工程指示 / 要求簡箋(E.I.)

工程指示編號：EI / 3372 / 21 修改版次：B  
 工程編號：J - 852 工程名稱：亞皆老街中電  
 工程項目：鐘樓-Skylight 地盤用鋁板 (加工)  
 收件人：生統 發件人：Ant Yeung 日期：06/07/2021

TITLE: VERTICAL DETAIL FOR SKYLIGHT

1 VERTICAL DETAIL  
SCALE 1:2

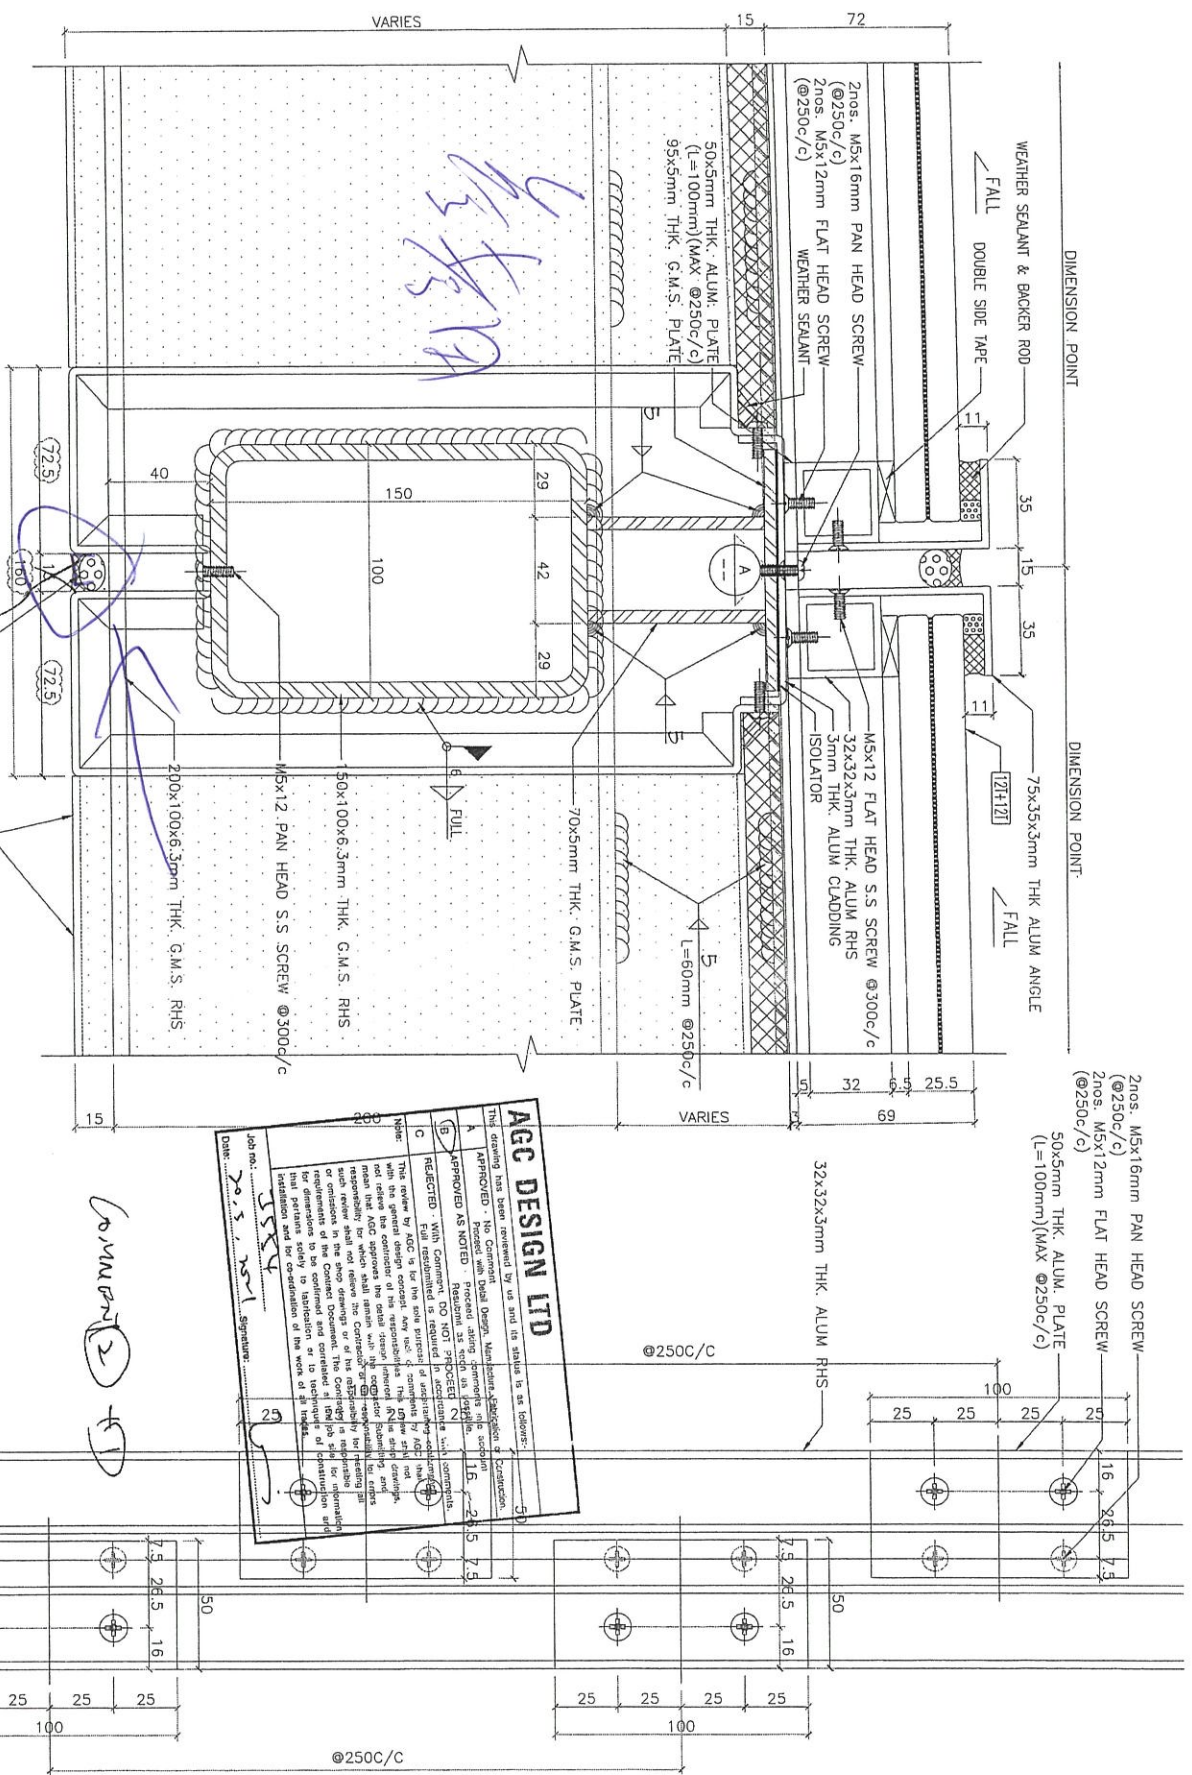
B 版：按則師 comment 加室內~~正~~遮膠隙 室內白 放行噴塗室內顏色: UCT902435SC-3 (白)

\* COMMENT ①:  
To eliminate 15mm gap /  
for Alum. curtain to cover if  
necessary
